## MY1 Monitoring Report

Owen Farms Mitigation Site  
Transylvania County, NC

NCDMS Project No. 100064  
NCDMS Contract No. 7532  
NCDMS RFP No. 16-007334  
(Issued 9/8/2017)

Re: MY1 Monitoring Report Comments  
Owen Farms Stream and Wetland Mitigation Site  
French Broad River Basin; CU# 06010105 – Transylvania County  
DMS Project ID No. 100064  
Contract No. 7532  
SAW-2018-01165

**Table 14. Wetland Hydrology Summary**

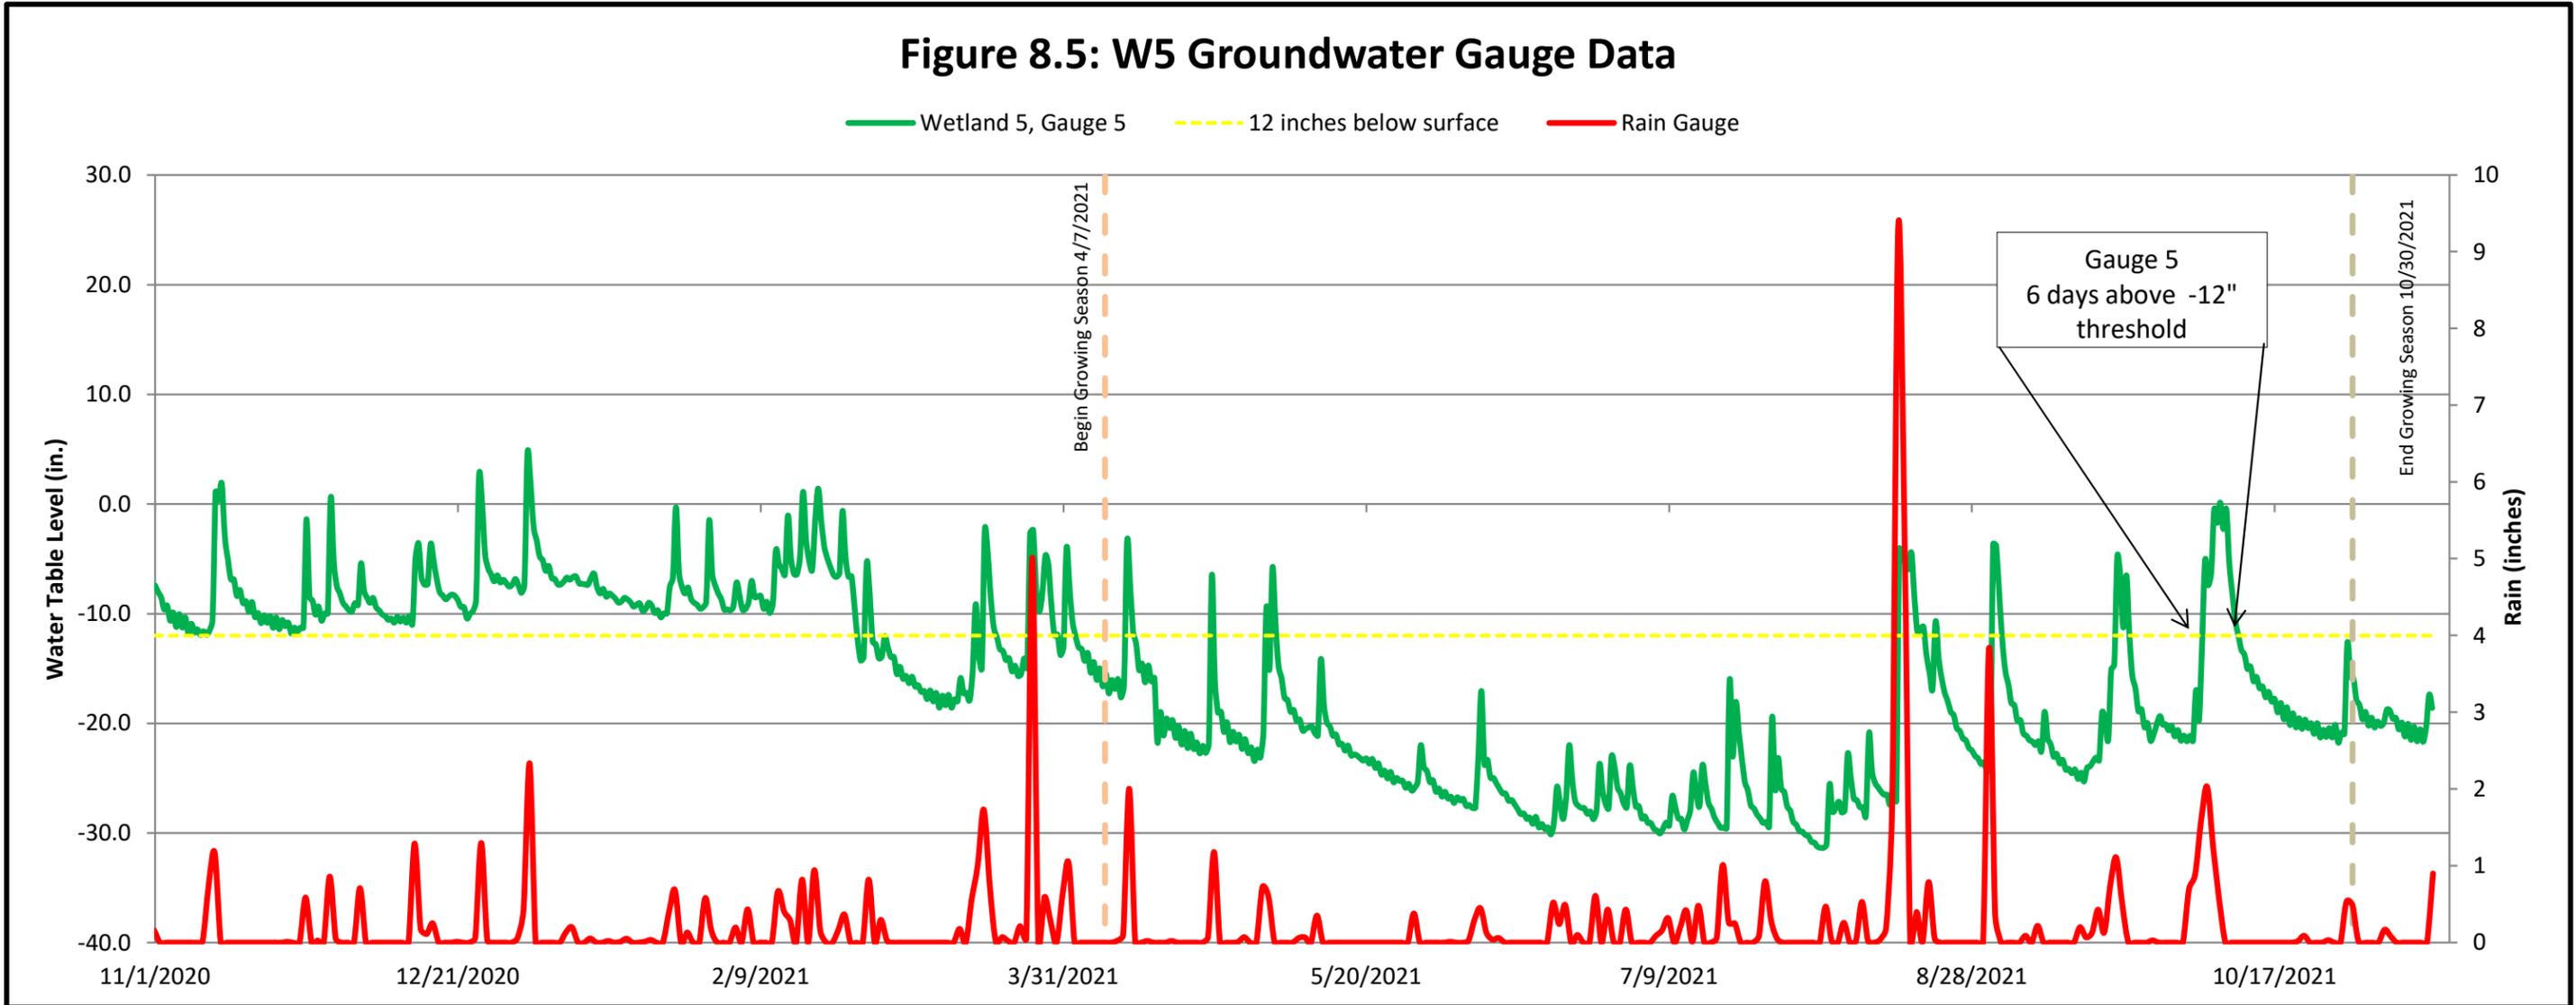
12. Please provide separate figures for each individual groundwater gauge. Please identify the maximum consecutive day number for each gauge on the individual plots/ figures. Please also review the max. consecutive hydroperiods (%) reported in Table 13. Groundwater gauges 1-3 are all reporting 75 days above the 12" threshold and the growing season is reported as 206 days ( $75/206 = 36\%$ ). Table 13 is reporting 42% for groundwater gauges 1-3. In Table 13, please include MY1/ 2021; MY2/2022; etc. Please review, QA/QC, and update the figures, table and report text as necessary *RE: Separate figures have been added to the MY 1 Report. Table 13 has been updated.*
